Bid Title: P.O. Hoffer Water Treatment Facility Glenville Lake Water Treatment Facility Post-Filter GAC Adsorption Facilities Contract No.67

Addendum Number: 5

ADDENDUM NO. 5 – TECHNICAL SPECIFICATIONS AND DRAWINGS

Project: P.O. Hoffer Water Treatment Facility and Glenville Lake Water Treatment Facility – Post-Filter GAC Adsorption Facilities – Contract No. 067

EL 91.00 - ENLARGED PLAN - LIGHTING

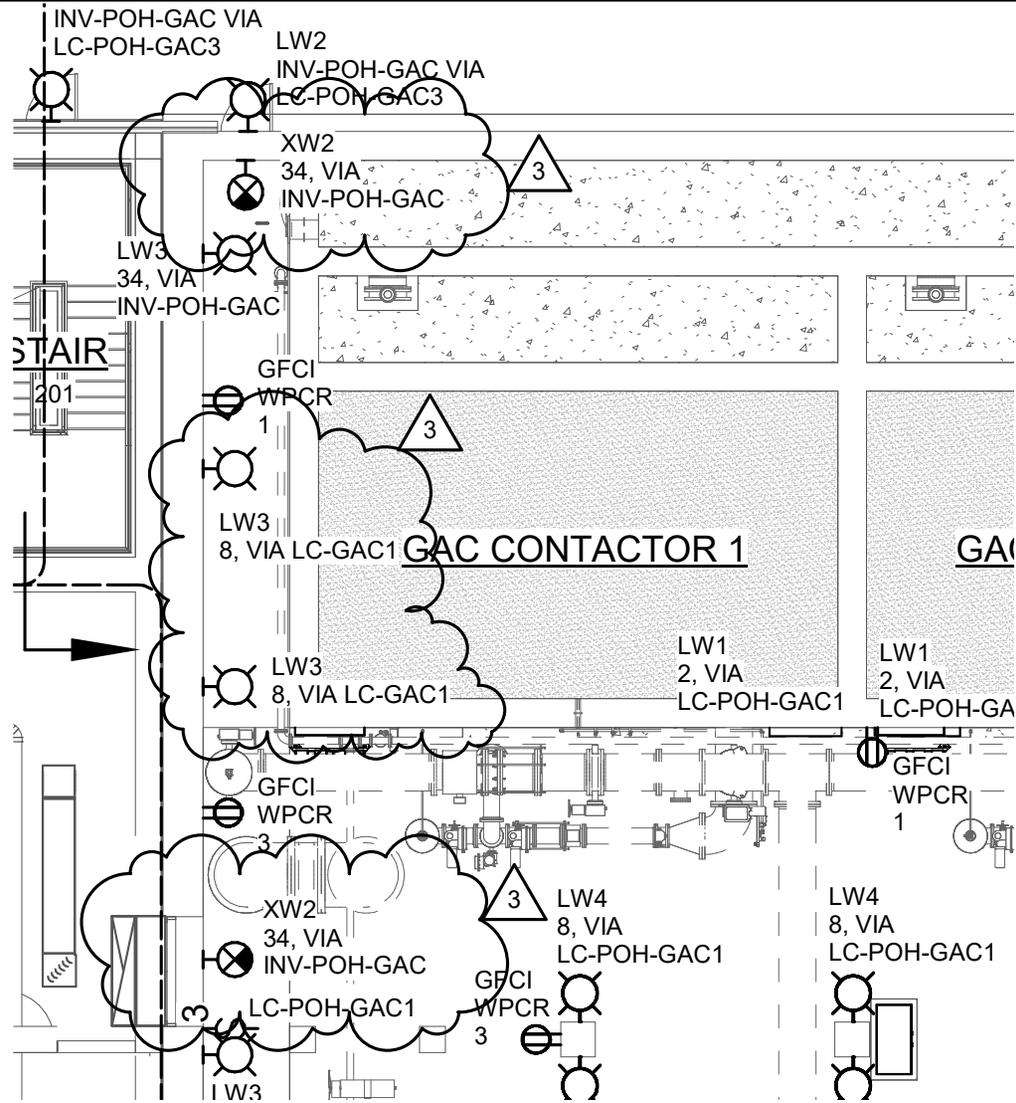
- E203 Revised Enlarged Plan – Lighting – Added circuit to light fixture XW1 as shown in **Attachment #1.**
- E206 Revised Bottom Plan – Lighting – Changed XW1 light fixture to XW2 light fixture. Changed some light fixtures LW3 circuits from (34, via INV-POH-GAC) to (8, via LC-GAC1) as shown in **Attachment #2.**

EL 91.00 - BOTTOM PLAN - LIGHTING

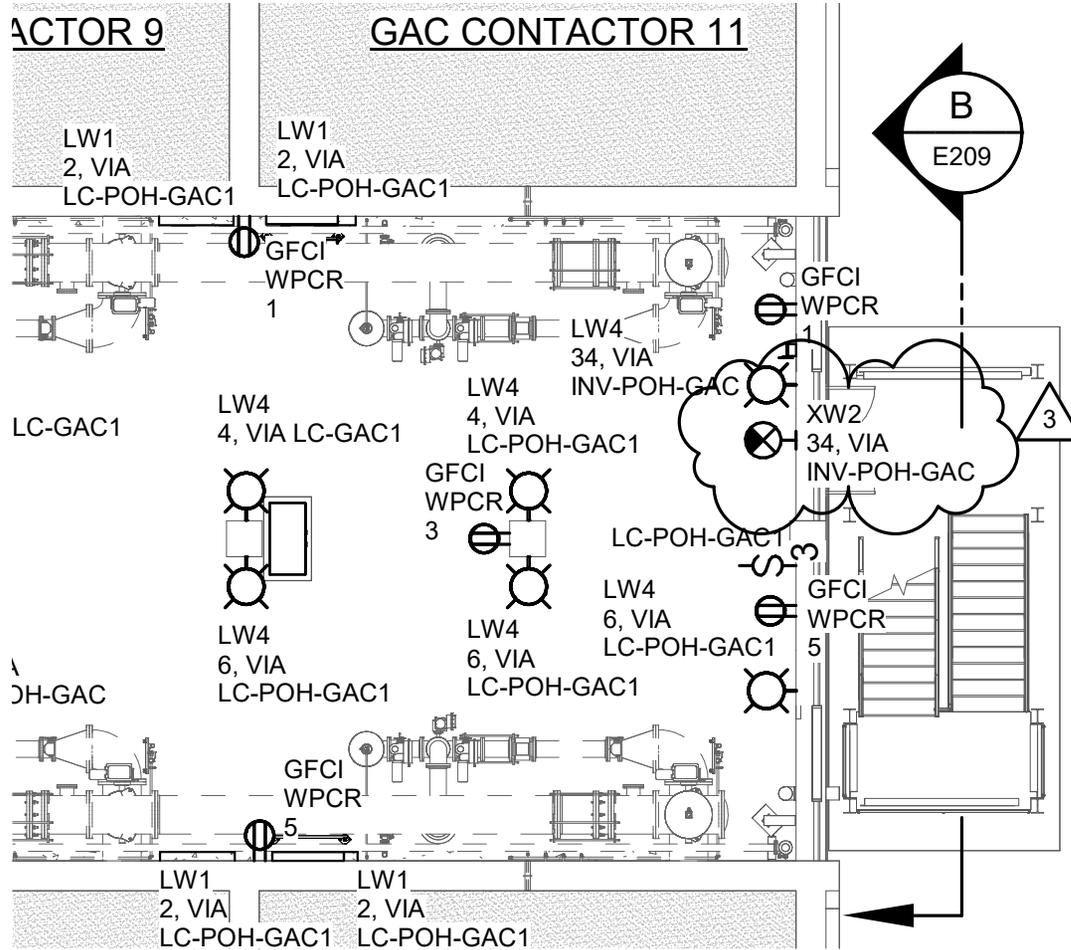
- E206 Revised Bottom Plan – Lighting – Changed XW1 light fixture to XW2 light fixture. Changed some light fixtures LW3 circuits from (34, via INV-POH-GAC) to (8, via LC-GAC1) as shown in **Attachment #3.**

EL 91.00 - BOTTOM PLAN - LIGHTING

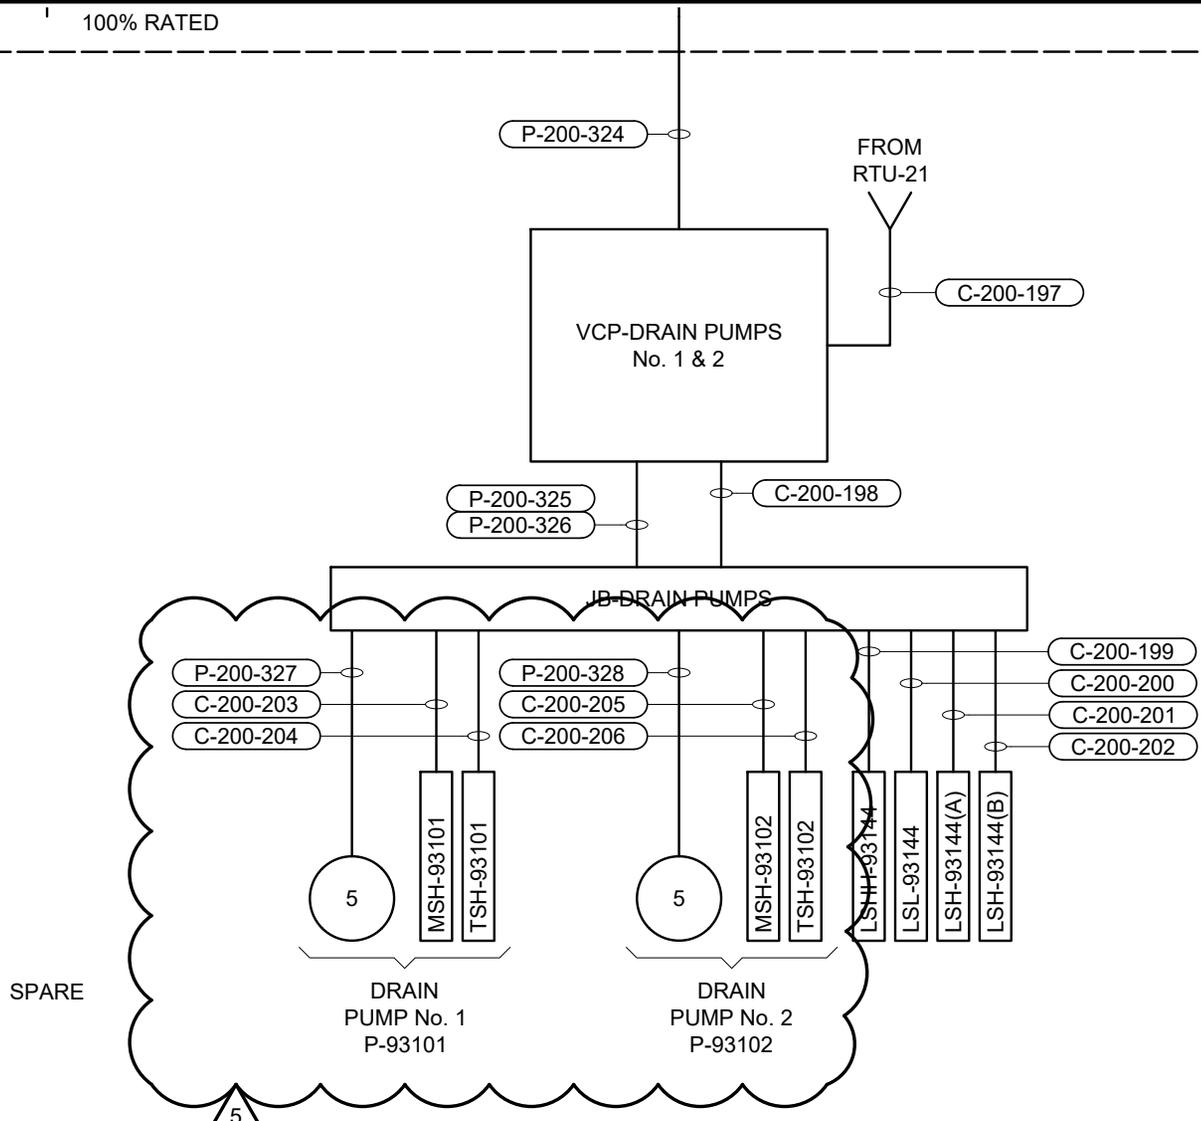
- E206 Revised Bottom Plan – Lighting – Changed XW1 light fixture to XW2 light fixture as shown in **Attachment #4.**
- E211 Revised SWBD-POH-GAC single line diagram to add motor space heaters and temperature switches to drain pumps No. 1 and No. 2. as shown in **Attachment #5.**
